# REGIONAL REVIEW NOTIFICATION

**ARC REVIEW CODE:** R1811051

**Name of Proposal:** Crossroads Business Center (DRI 2854)

**CROSSROADS BUSINESS CENTER DRI**  
**City of Union City**  
**Natural Resources Group Review Comments**

# DRI-1

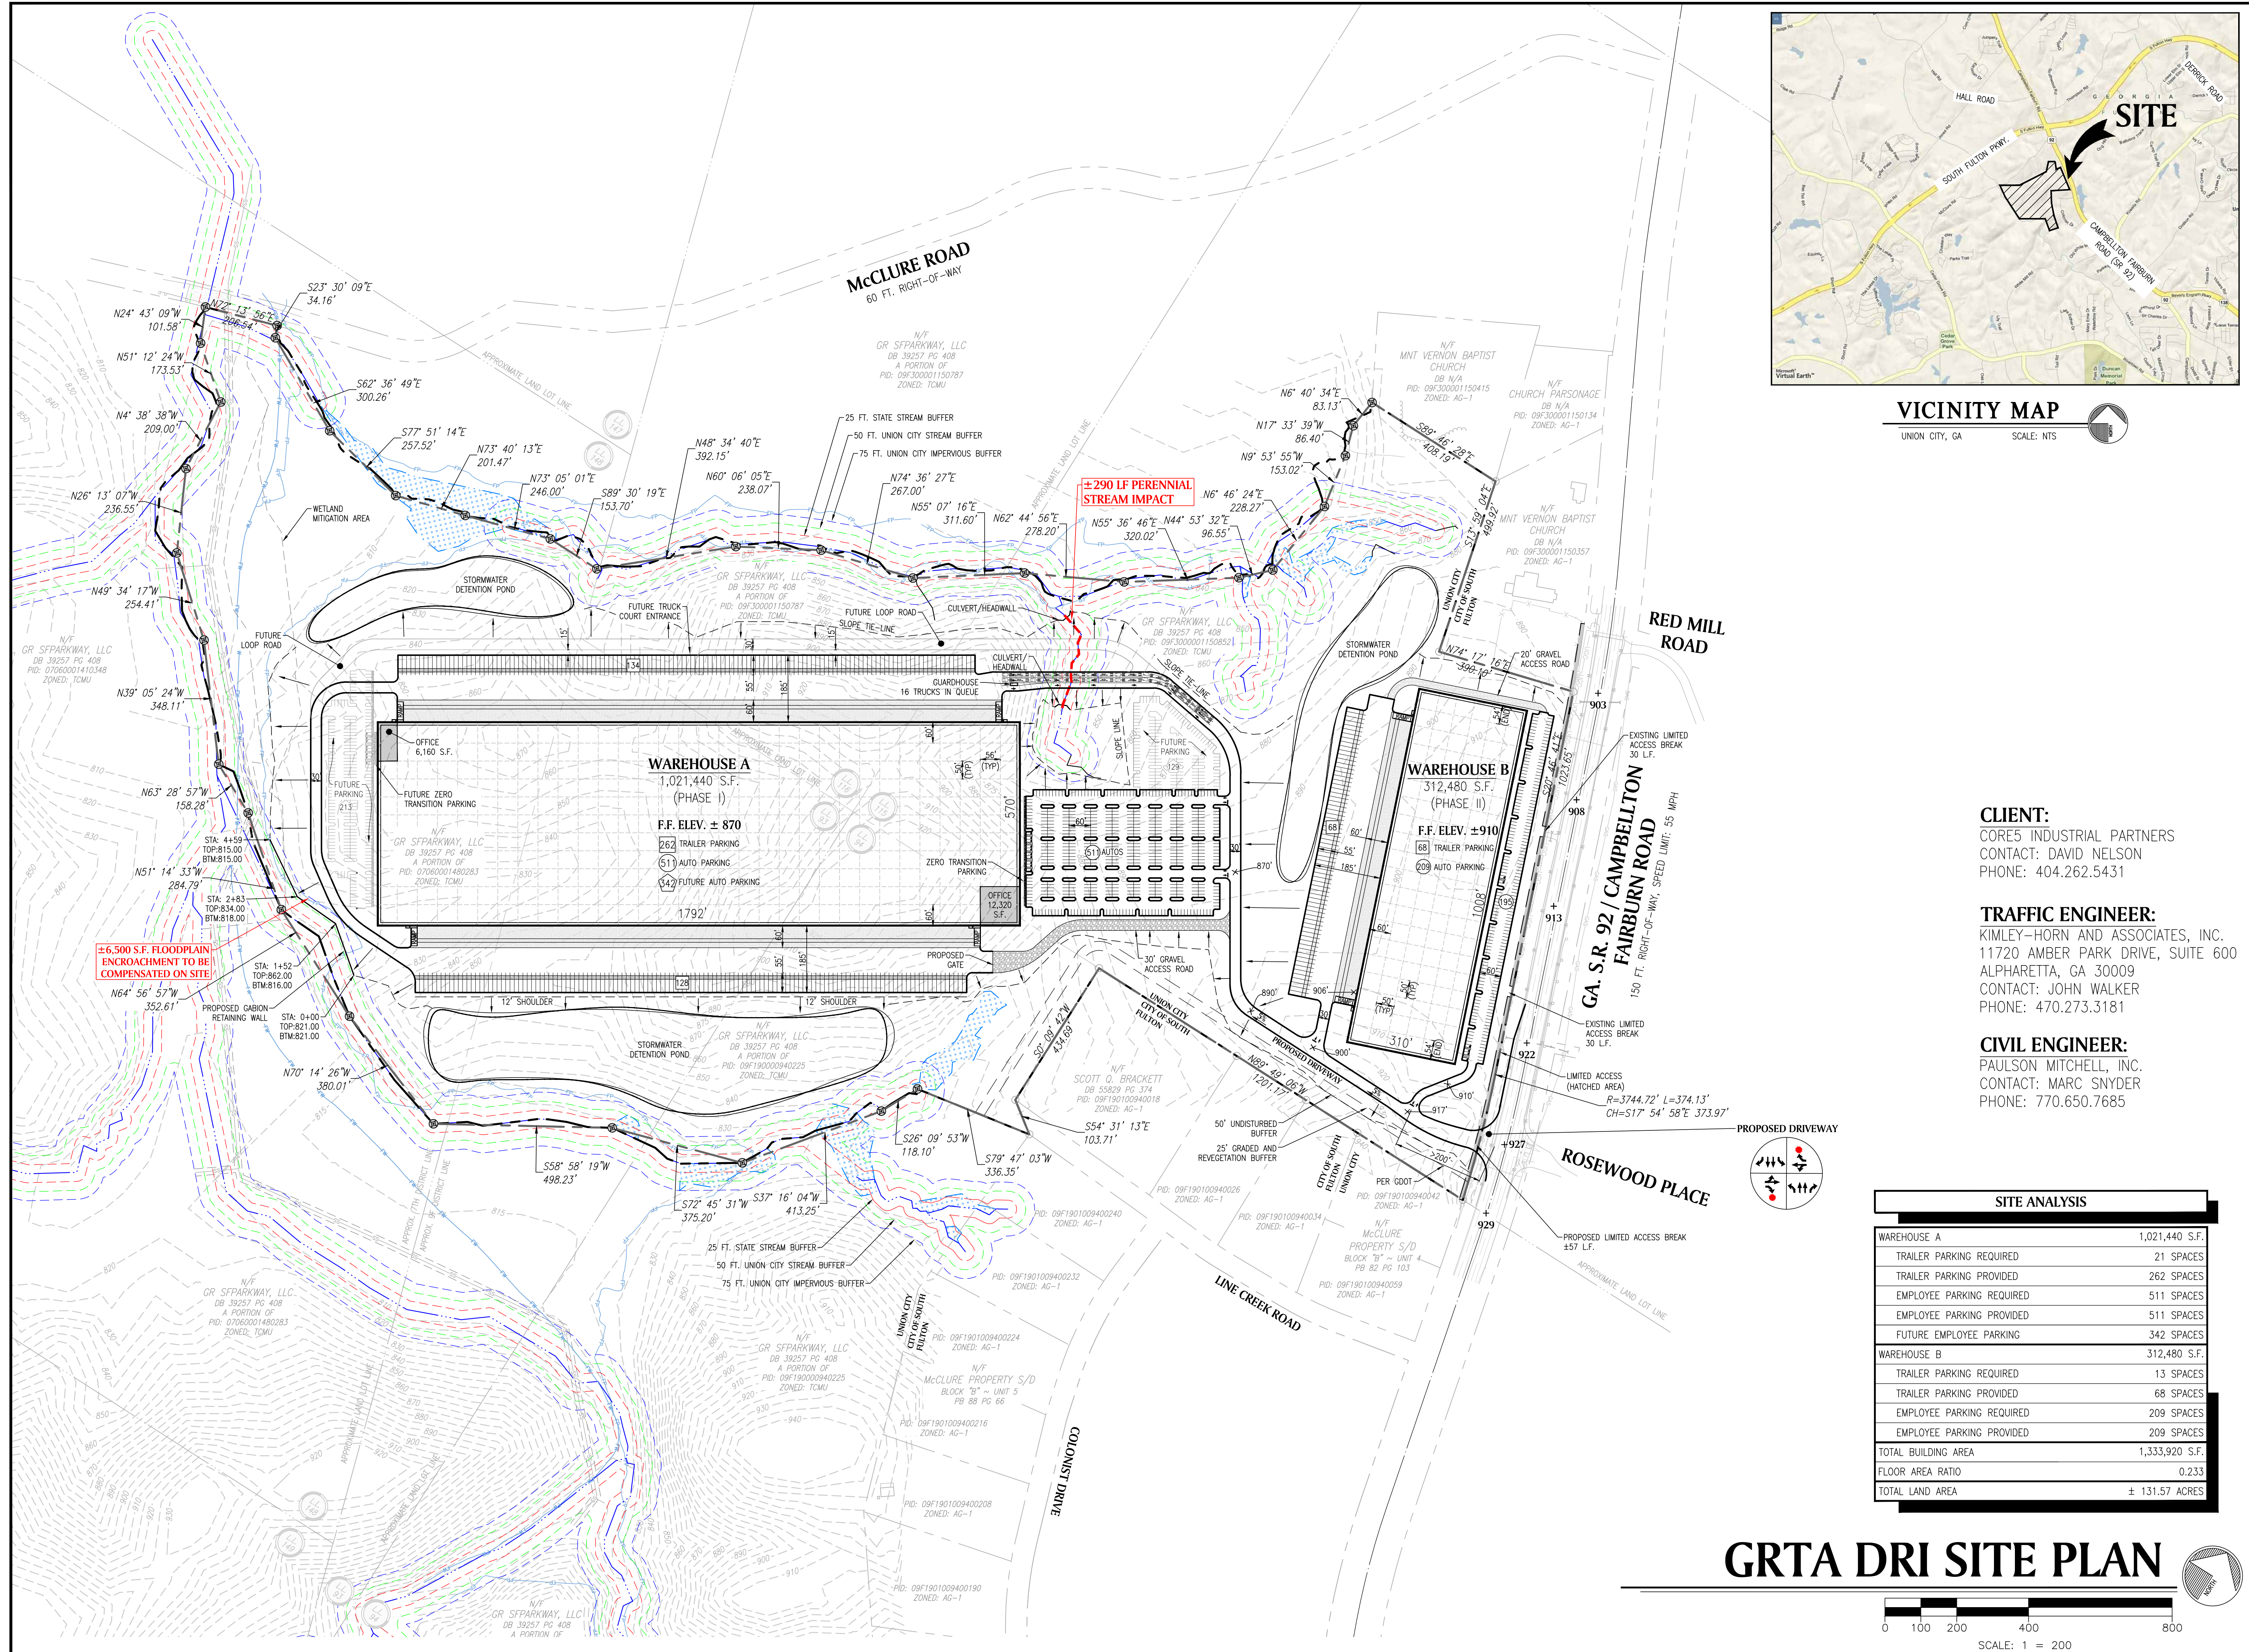
Both the USGS coverage for the project area and the submitted site plan show Line Creek, which is a tributary to Deep Creek, running along the southwestern (or rear) project property line. In addition, the site plan shows streams along the eastern and northwestern sides of the property, each with short branches running into the property. The site plan shows and identifies the 25-foot State Sediment and erosion control buffer, the 50-foot City stream buffer and the 75-foot City impervious setback on all streams shown on the property. The site plan shows one branch of the northwestern stream as impacted by the proposed development, with about 290 feet culverted for a road crossing. This activity will most likely require variances from both the State and City buffers. The site plan does not show any other proposed activity within the stream buffers. Any unmapped streams may also be subject to the requirements of the State and City buffers. Any unmapped waters of the state may be subject to the state 25-foot sedimentation and erosion control buffer requirements.

The site plan shows one proposed site access from GA SR 92, a regional thoroughfare.

No existing bike ped facilities exist along the SR 92 and none appear to be proposed internal or external to the site.

The development does not propose bike or pedestrian facilities internal or external to the site.

One driveway will provide access for both heavy truck and vehicle traffic entering and exiting the site.

ARC encourages developments to incorporate alternative modes of transportation access to the site. In this case, sidewalks should be included to provide a safe alternative mode of pedestrian access to the site.
